UNIVERSITY OF VIRGINIA
NUCLEAR REACTOR FACILITY

Subject: UNIVERSITY OF VIRGINIA – (Second) REQUEST FOR ADDITIONAL INFORMATION
RE: DECOMMISSIONING AMENDMENT REQUEST (TAC NO. MA8186).

**UVA RESPONSE TO NRC REQUEST FOR ADDITIONAL INFORMATION
UNIVERSITY OF VIRGINIA RESEARCH REACTOR
DOCKET NO. 50-62**

Figure 1: Pond Sediment Sampling Locations And
 Groundwater Monitoring Well Locations

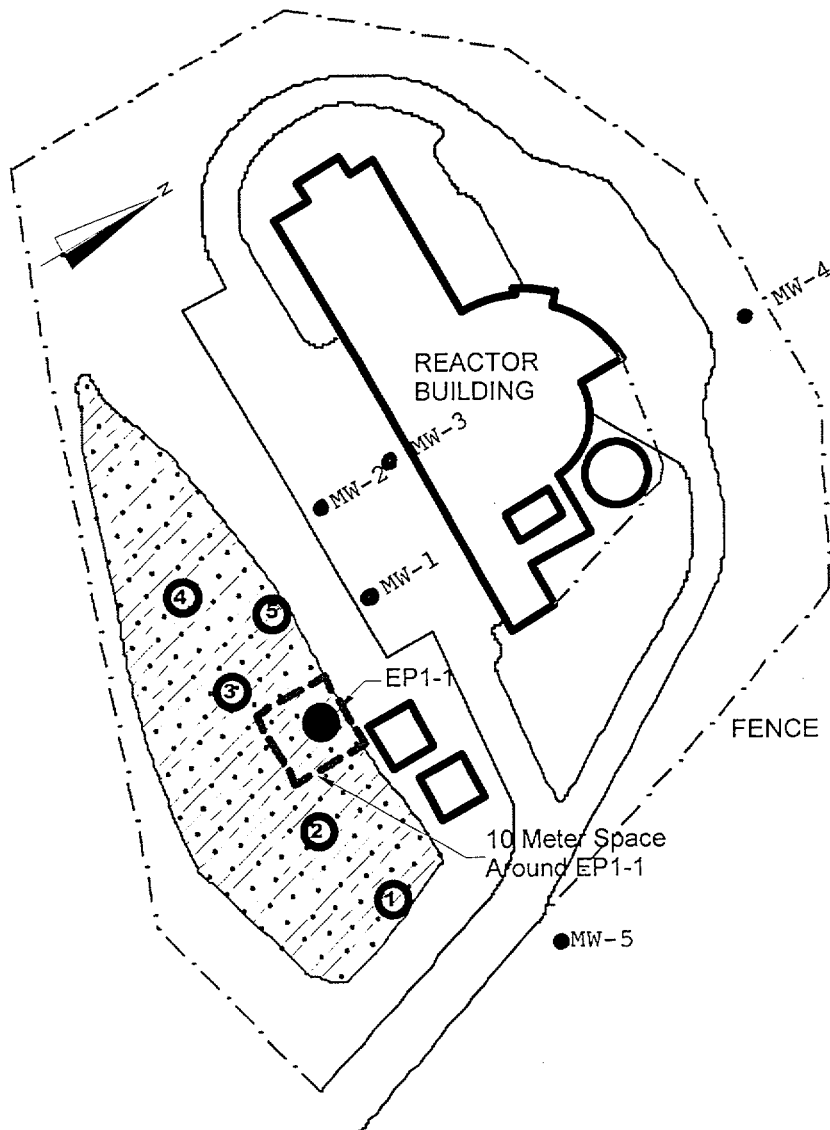
10. Please describe the plan for characterizing the pool leakage pathways. Will this include an investigation of the hydrology present on the site? If not please justify. Will the characterization include sampling existing waterways, existing wells, and test wells? If not, please justify.

- 11. Beginning on page A-3 of Appendix A of the DP (Ref. 3)" ...areas that will require remediation or further investigation and evaluation..." are listed. One sample, Location No. 14, was a composite sample of pond sediment taken at the outfall area of the liquid waste holding tank bunker. As indicated on page A-6 of the DP and in Table 7.4 of the UVAR Characterization Survey Report (CSR) (Ref. 5) levels above the DCGLs for Co-60 and Cs-137 were found. Please discuss the plan for further characterization, evaluation, and remediation of the pond sediment. Please provide the estimate of the impact this activity will have on the schedule, personnel dose, waste volume, and decommissioning cost.**

Mr. Sitler re-visited the UVAR site in early April, 2001, to advise on how additional hydrological site characterization could be conducted. Suitable locations (please see Figure 1 in attachment) were found for two additional groundwater test sampling wells, one (MW4) directly north of the Reactor building (hydrologically upstream in unimpacted groundwater), and the other (MW5) near the pond retaining wall (hydrologically downstream, at a potentially impacted location). UVA is hereby committing to NRC that it will have these groundwater sampling wells drilled. The additional water table data to be obtained is expected to confirm the present understanding of the site hydrology. In addition, water samples from new and existing site wells, nearby wells on the other side of the hillside on which the UVAR site is located, and nearby surface waters, will be taken and evaluated for a potential UVAR poolwater leak impact.

The statement on page A-6 of the DP indicating that Cs-137 was in excess of the DCGLs was incorrect. The sample result for Cs-137 was 3.7 pCi/g and the DCGL for Cs-137 is 11 pCi/g. However the Co-60 result, 9.5 pCi/g, was in excess of the DCGL, 3.8 pCi/g, as indicated. The attached survey map (please refer to attached Figure 1) shows as circled

numbers the sediment sample locations 1 to 5 plus sample locations EP1-1. Only sample location EP1-1 had activity in excess of the proposed DCGLs as indicated on the attached pond sample result table (please see Table 1 in attachment). The EP1-1 sample was taken in the immediate vicinity of the drainpipe from the reactor building. The 10-meter space on the map shown around sample location EP1-1 indicates the maximum anticipated extent of contamination.

Figure 2: Office of Environmental Health and Safety
Organizational Chart

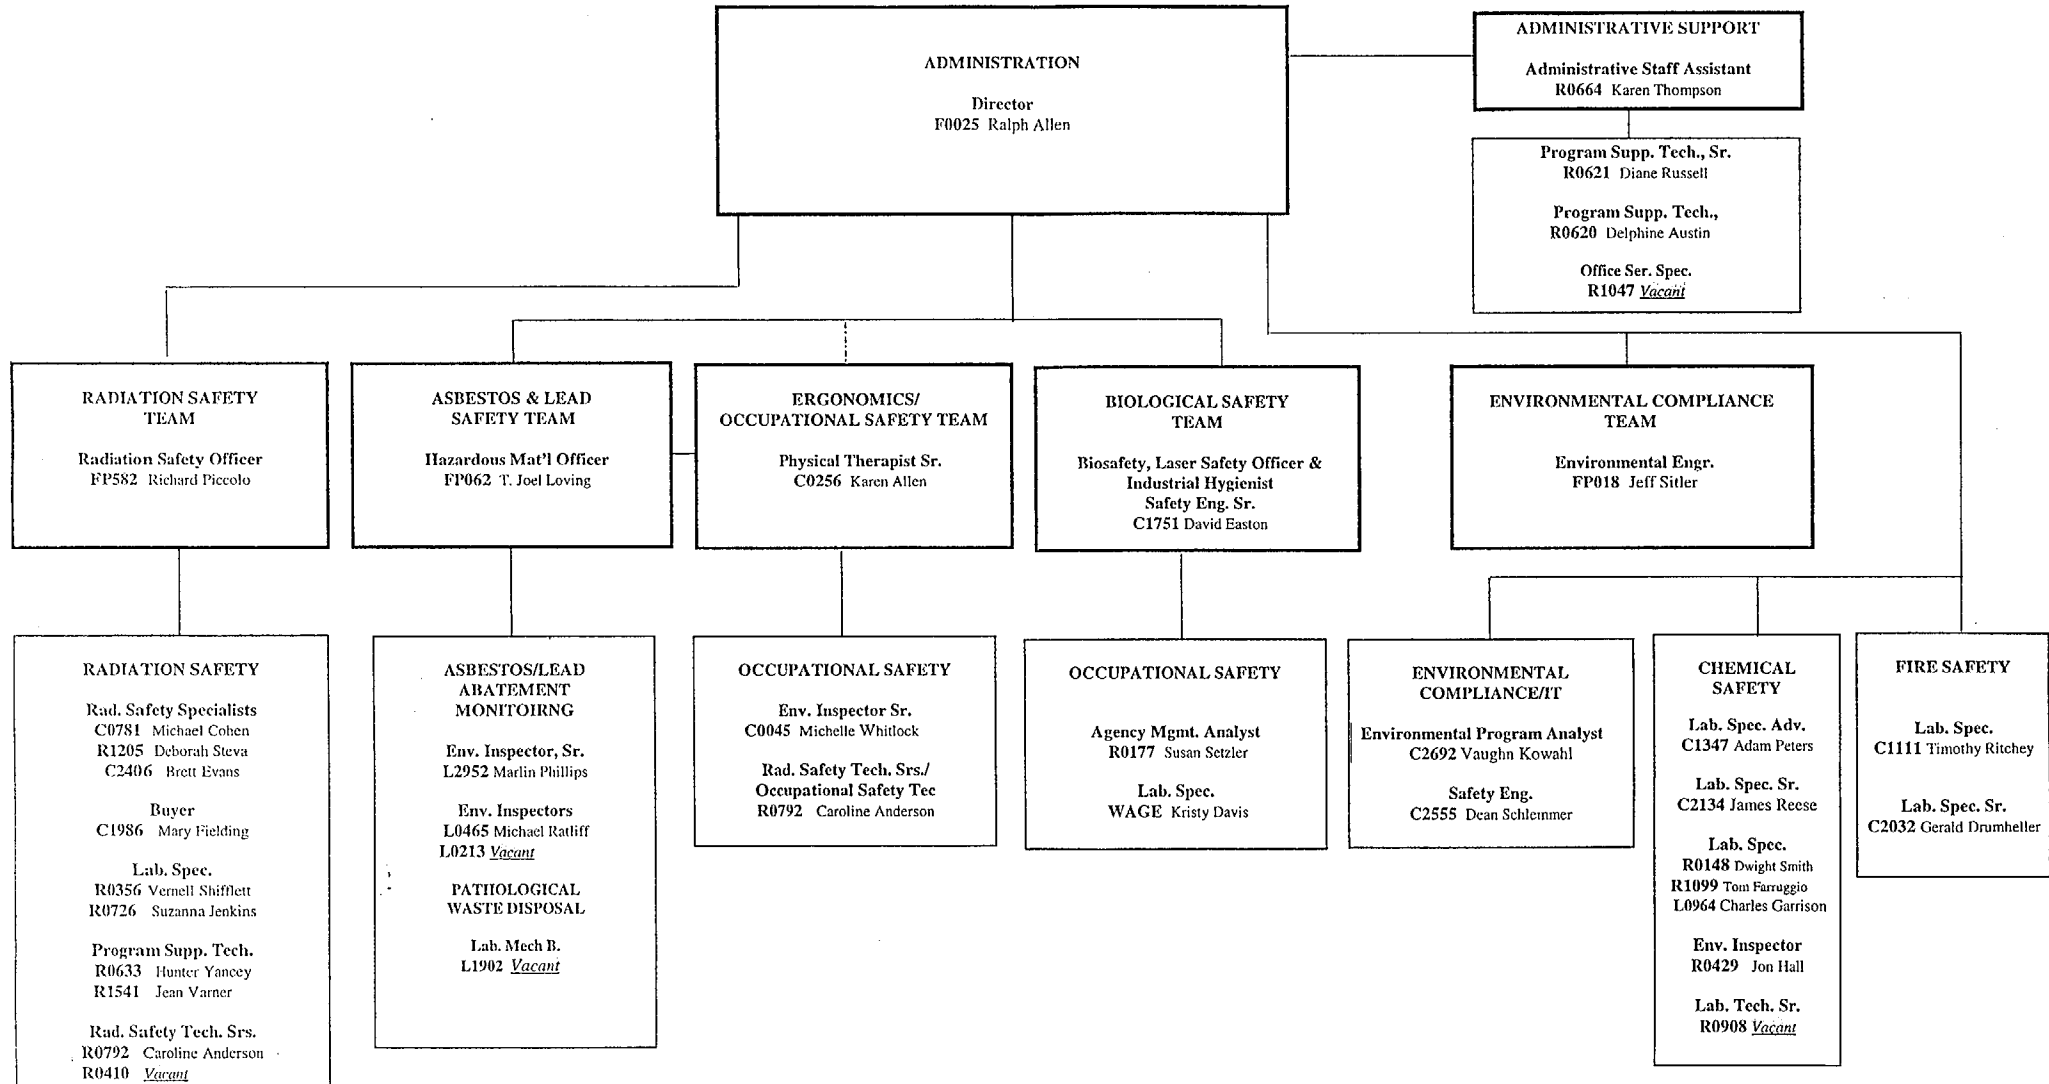
4. **The position "UVA Industrial Hygiene (IH)" is referred to in the Respiratory Protection part of section 3.1.2 of the DP (Page 3-8, Ref. 3). Please provide the position with supervisory control over the IH position. Please list the responsibilities of the IH position.**

6. **What are the distinctions and relations between the Radiation Work Permit (RWP) and the Hazardous Work Permit (HWP)? Both are referenced in section 3.2.2 of the DP (Page 3-18, Ref. 3). With whom lie the responsibilities associated with HWPs?**

The UVA industrial hygienist (certified by the American Board of Industrial Hygiene), serving as Biosafety, Laser Safety Officer and Industrial Hygienist Safety Engineer Sr., will be consulted to advise the decommissioning contractor on issues about air quality and the use of respiratory protection. The Director of Environmental Health and Safety, who also serves as Chairman of the Decommissioning Committee, has supervisory control over this position. (Please refer to Figure 2, in attachment, which depicts the organizational chart of the Office of Environmental Health and Safety.)

An HWP will be used when controls are imposed to protect against non-radiological hazards. Depending on the hazard, the appropriate OEHS specialist will assist with the development of the HWP. The UVA Occupational Safety Environmental Inspector Sr. will be responsible for approval of HWPs. The Director of Environmental Health and Safety, who also serves as Chairman of the Decommissioning Committee, has supervisory control over the Environmental Inspector Sr. position. (Please refer to Figure 2, in attachment, which depicts the organizational chart of the Office of Environmental Health and Safety.)
